STAKEHOLDER/I&AP QUERY/COMMENT	STAKEHOLDER / I&AP	EAP/SPECIALIST/DEVELOPER RESPONSE
EIA PHASE COMMENTS AND RESPONSE REPORT		
Please ensure that all relevant listed activities are applied for, are specific and can be linked to the development activity or infrastructure as described in the project description.	Department of Forestry, Fisheries and the Environment (DFFE) Comments on Draft EIR Competent Authority 14/07/2021	Please see table 2-6 of the Draft Amended EIR.
Please ensure that activities applied for in the application form for EA must be the same as those mentioned in the report. If the activities applied for in the application form for EA differ from those mentioned in the EIAr, an amended application form must be submitted with the final EIAr.		Please see table 2-6 and the Updated Applicable Form.
Please ensure that all issues raised and comments received during the circulation of the draft EIAr from registered I&APs and organs of state which have jurisdiction (including this Department's Biodiversity Section) in respect of the proposed activity are adequately addressed and included in the final EIAr. Proof of correspondence with the various stakeholders must be included

Figure 1: Indalo PE proposed expansion in relation to proposed renewable energy developments in the region.

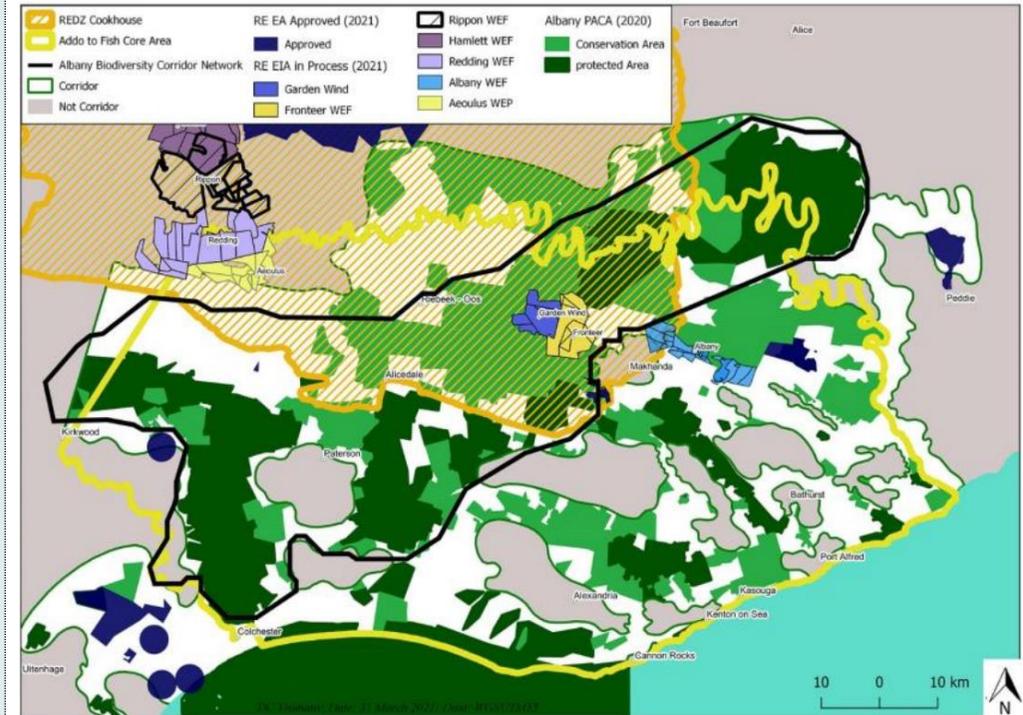
Protected Area. Thus, the WEF must respect the historic rights and legitimate interests of Indalo and the other Protected Areas. (The expansion of Protected Areas and creation of buffer zones are prescribed by the existing law and government have developed and is implementing expansion polices, strategies and plans over many years (discussed below).) It is Indalo’s view that negative environmental impacts of the WEF will cause a significant and permanent impairment of the undisturbed enjoyment of the Indalo and Great Fish Protected Areas as well as of the future Mega Protected Area.

The proposed Albany WEF is not situated within a Protected Area, nor is the site situated on land which would disrupt the conglomeration of the land between the Great Fish River Reserve and the Addo Elephant National Park. The I&AP suggests that all land surrounding the proposed corridor should be sterilised for any and all opposing developments. This would essentially infringe on the rights of the landowners (of which the Albany WEF landowners are some) to investigate and proceed with alternative developments outside of the ecotourism industry.

Figure 1: Indalo PE proposed expansion in relation to the Wilderness Value ratings of the region.

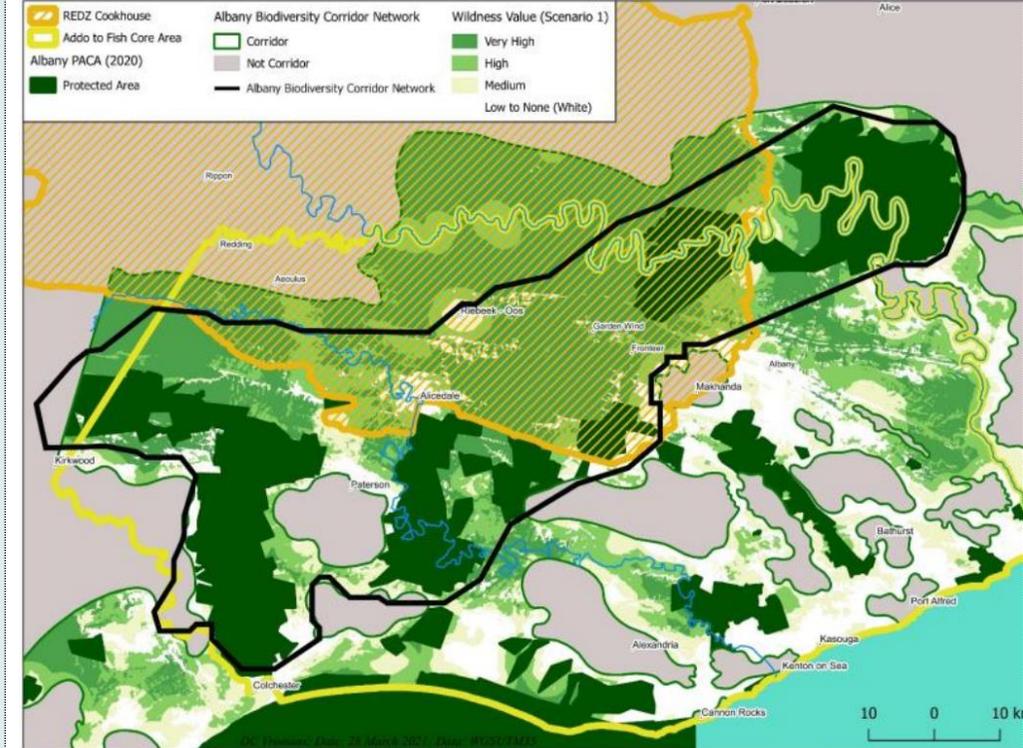
Based on the Indalo PE/ECPTA/SANParks proposed expansion plan “Albany Biodiversity Corridor Network” the area proposed for the Albany WEF is of **LOW** “Wilderness Value” (see Figure 1 below). In addition to this point all ecological specialist reports (ecological, bat and avifauna) have undertaken numerous site visits to ensure that areas of high ecological value are avoided (NO-GO areas) and mitigated (HIGH and MODERATE areas).

The I&AP is suggesting that the Albany WEF would essentially derail the proposed Albany Biodiversity Corridor Network. This assertion is flawed since an operational WEF (Waainek WEF) has been included **WITHIN** the proposed corridor (see Figure 1 below). In addition to this point, the fact that the Albany WEF is proposed on land regarded as having a **LOW** “Wilderness Value” would suggest that this land has been excluded as it is not suitable for future expansion purposes. It is assumed that this is due to the conflicting land uses, such as mining, industrial development (such as the Eskom Albany Substation, Eskom distribution powerlines and numerous telecommunication towers). To deprive the current landowners

Figure 1: Indalo PE proposed expansion in relation to proposed renewable energy developments in the region.

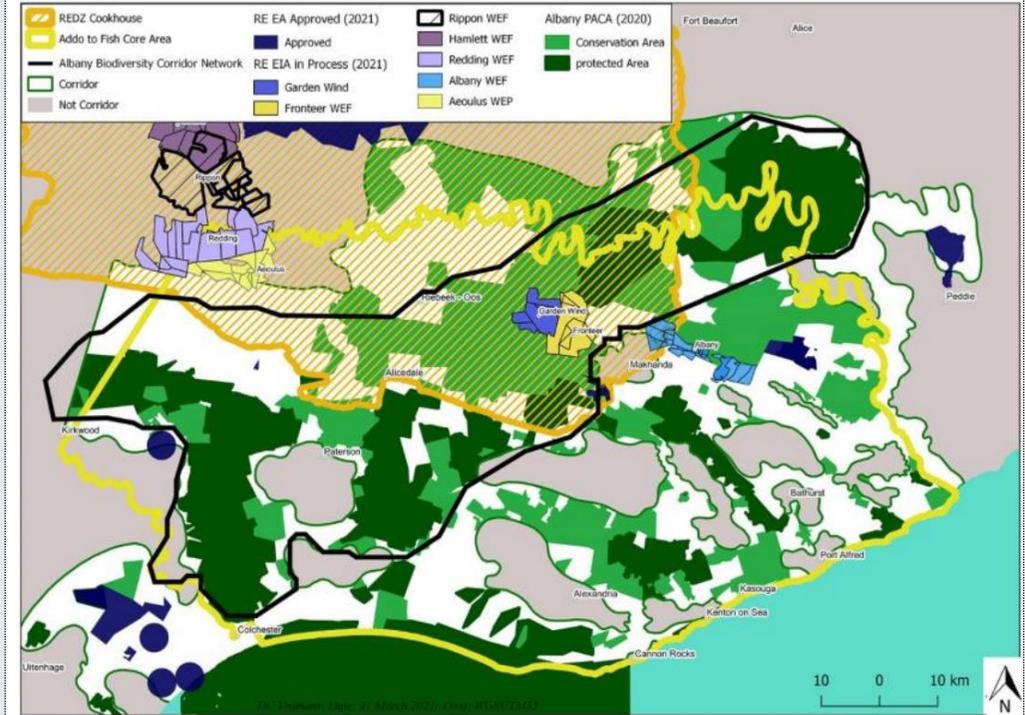
2.3.16 All the purposes in section 17 of NEMPAA apply to Indalo, Great Fish and Addo. The underlined provisions of section 17 require that Indalo and the other Protected Areas must, (i) provide environmental goods and services, (ii) create an environment that is conducive for nature-based tourism, and (iii) ensure ecological sustainable social and economic development takes place. Similarly, the purposes in section 28(2) of NEMPAA apply specifically to the Indalo. This means that Indalo must (i) form a buffer zone between the Addo and Great Fish, (ii) enable the different PGRs inside Indalo to conserve their biodiversity, (iii) protect sensitive areas in respect of economic development e.g. areas with scenic and landscape value, and (iv) provide environmental goods and services.

of the economic opportunity of the proposed WEF when their land is not earmarked for inclusion into this plan is neither just nor fair. The proposed Albany WEF would not impose on, disrupt or deter the establishment of the “Albany Biodiversity Corridor Network”.

Figure 2: Indalo PE proposed expansion in relation to the Wilderness Value ratings of the region.

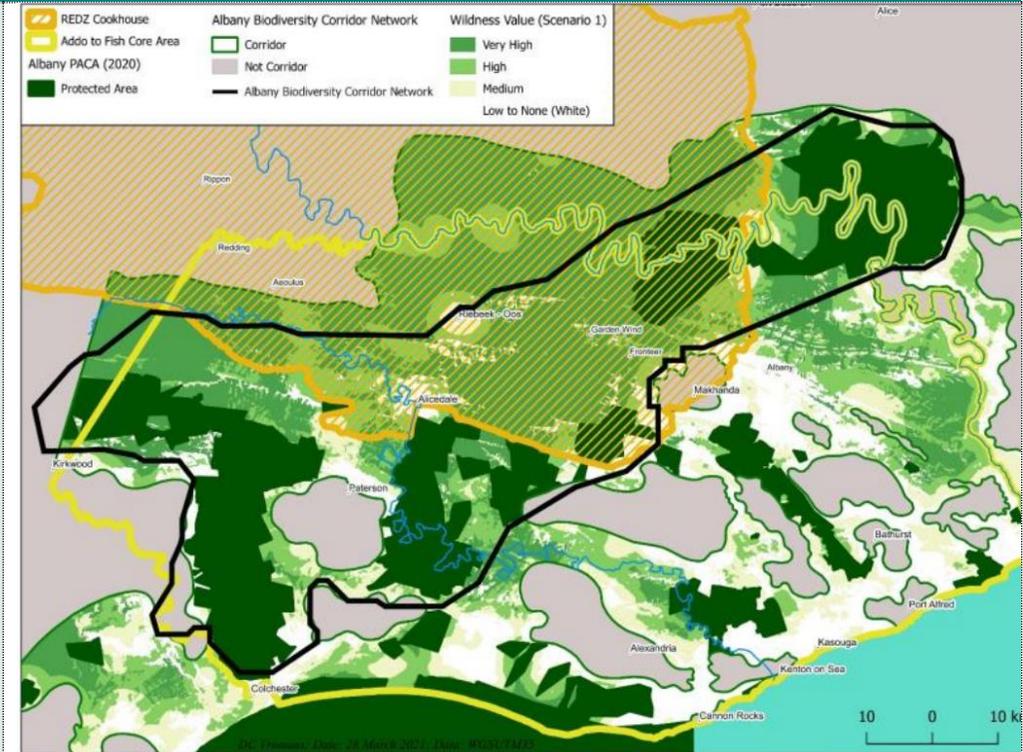
2.3.17 Legal error: Indalo objects against approval of the Albany WEF because the development will prevent Indalo from fulfilling its statutory obligations (purposes) in sections 17 and 28 of NEMPAA. (This is also the case for the Great Fish and Addo in respect of their obligations under section 17.) This is so because the environmental impact of the WEF will affect the ability of the Protected Areas to adequately provide some of the environmental goods and services (e.g. game drives and walks, experiencing wildlife in their natural habitat, nature photography, wildlife education, game cuisine and cultural interaction with local communities), will significantly affect nature-based tourism and is not ecologically, socially and economically sustainable because it will cause the reduction of visitors to some of the Indalo PGRs and Protected Areas. In this regard we refer to the negative effect of the Waaihoek WEF on tourism to Pumba (see Pumba letter attached) which confirm these risks as real and not miniscule or theoretical as appears to be the impression created in the EIR and SIA.

Figure 1: Indalo PE proposed expansion in relation to proposed renewable energy developments in the region.

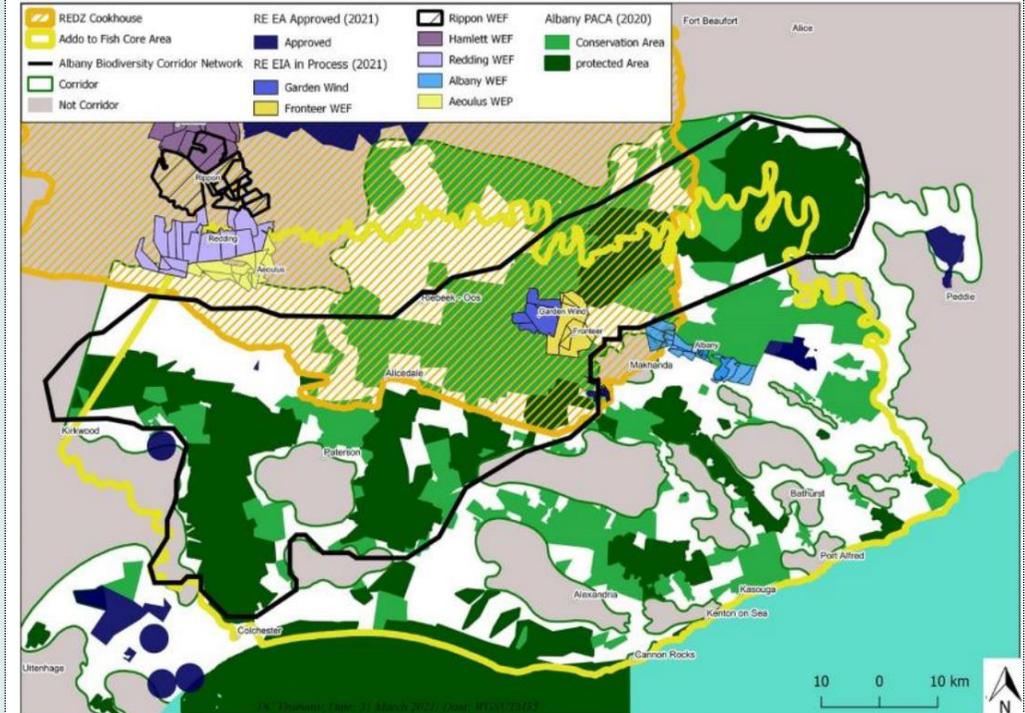
recommendation to the DEFF to provide conditional environmental authorisation (EA) for the development of the Albany WEF will affect the ability of Indalo and the other Protected Areas to comply with their legal obligations under section 17 and 28 of NEMPAA, respectively (as underlined). This effect by the environment authorisation will be contrary to the rule of law, and thus unlawful and unconstitutional conduct. If the Applicant receives EA for the Albany Wind Farm development, Indalo reserves its right to have it set aside on internal appeal to the Minister, or on judicial review in terms of sections 6(2)(d) and (i) of the Promotion of Administrative Justice Act, 3 of 2000 (“PAJA”) as well as the right to obtain interdictory relief where necessary.

(see Figure 1 below). In addition to this point, the fact that the Albany WEF is proposed on land regarded as having a **LOW** “Wilderness Value” would suggest that this land has been excluded as it is not suitable for future expansion purposes. It is assumed that this is due to the conflicting land uses, such as mining, industrial development (such as the Eskom Albany Substation, Eskom distribution powerlines and numerous telecommunication towers). To deprive the current landowners of the economic opportunity of the proposed WEF when their land is not earmarked for inclusion into this plan is neither just nor fair. The proposed Albany WEF would not impose on, disrupt or deter the establishment of the “Albany Biodiversity Corridor Network”.

Figure 1: Indalo PE proposed expansion in relation to proposed renewable energy developments in the region.

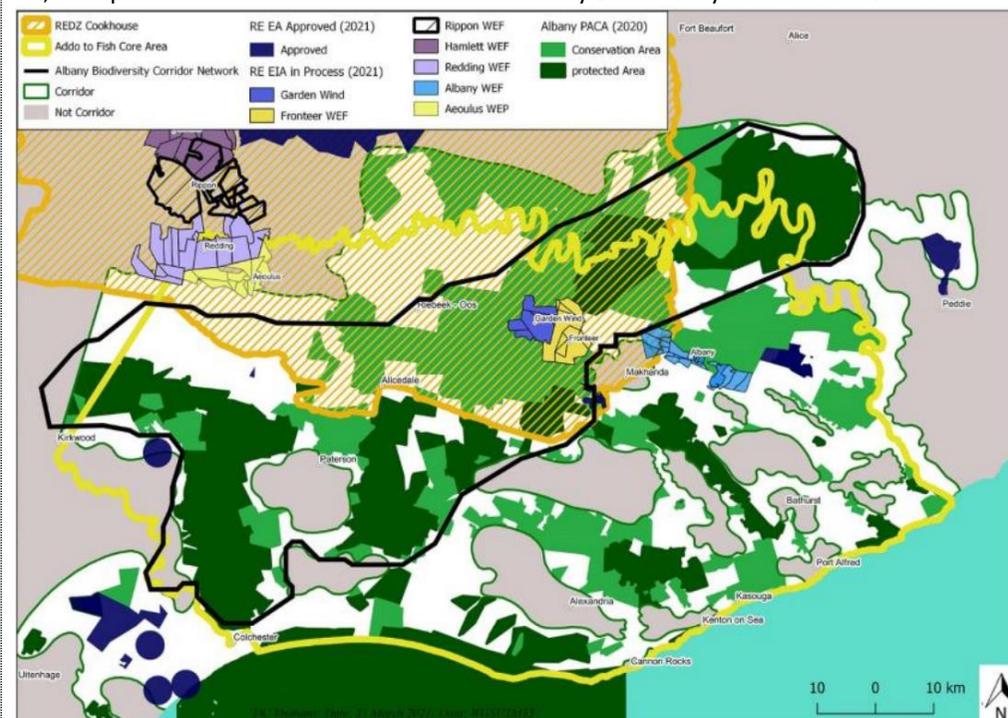
Like the other Indalo reserves (and many others in South Africa and in Africa in general); Pumba focusses on nature and wildlife tourism that relies on the wilderness character of the reserve and surrounding area. Legacy land management failures have left large areas of Makana overrun with alien vegetation, such as black wattle, blue gum (eucalyptus) and various others. Pumba has persistently worked to remove these species amongst others with the local community and Working for Water. For almost 15 years, this partnership has cleared large swathes of land throughout the reserve and continues to play an important role in maintaining the environment to its natural state. Pumba has made a substantial contribution to the conservation of rhino and lion, and more specifically white rhino and white lion. Pumba has worked with Indalo and other partners including the Wilderness Foundation and others to ensure the survival of the black rhino. Ever since the devastating loss of 6 white rhino to poaching in 2014 Pumba is not making public disclosures about its black rhino which along with other Indalo members it is working to protect with ever increasing cost and effort. In 2007, the white lion project was started in association with the Global White Lion Protection Trust (based in the Timbavati area), we have played a key role in ensuring the survival of white lions in the wild (lions that carry the leucistic, gene) whilst maintaining healthy genetic diversity of a very small population of these rare animals. Today Pumba is home to the second known free-ranging, self-sustainable population of White Lions in Southern Africa.

Based on the Indalo PE/ECPTA/SANParks Albany Biodiversity Corridor Network the proposed Albany WEF is situated outside of the expansion area. Thus, the assertion that the WEF will intrude on the proposed expansion is flawed (see Figure 1 below).

In addition to this point, the fact that the Albany WEF is proposed on land regarded as having a **LOW** "Wilderness Value" would suggest that this land has been excluded as it is not suitable for future expansion purposes. It is assumed that this is due to the conflicting land uses, such as mining, industrial development (such as the Eskom Albany Substation, Eskom distribution powerlines and numerous telecommunication towers). To deprive the current landowners of the economic opportunity of the proposed WEF when their land is not earmarked for inclusion into this plan is neither just nor fair. The proposed Albany WEF would not impose on, disrupt or deter the establishment of the "Albany Biodiversity Corridor Network".

Figure 2: Indalo PE proposed expansion in relation to the Wilderness Value ratings of the region.

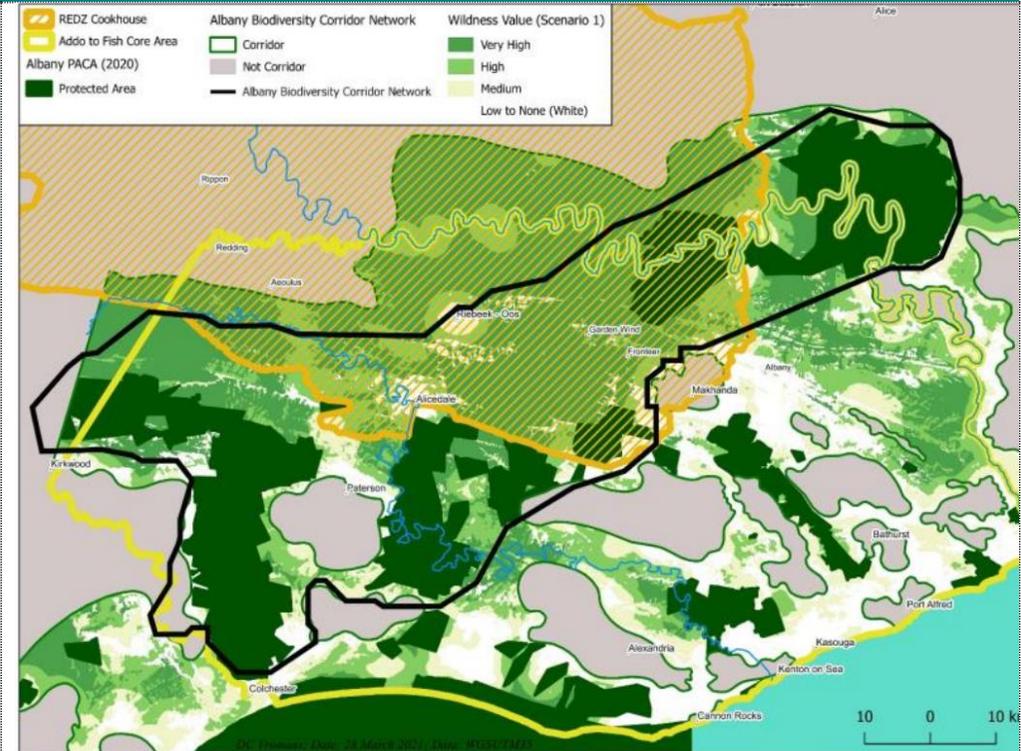
You may not be aware but The Tourism Grading Council of South Africa (TGCSA) classifies Private Nature Reserves accommodation as part of "Game or Nature Lodges". The visual and scenic quality of the natural environment of the private game reserves (along with wildlife and hotel specifications), are part of the minimum requirements to be a Game or Nature Lodge. Specifically it should be noted that it is a requirement to provide a "Scenic or natural vista (beyond that of the immediate garden area) e.g.: water view, rural outlook, mountain view or natural bush setting offering some Safari Activity such as Game Drives, Walking, Cycling, Horseback, Canoeing etc."1
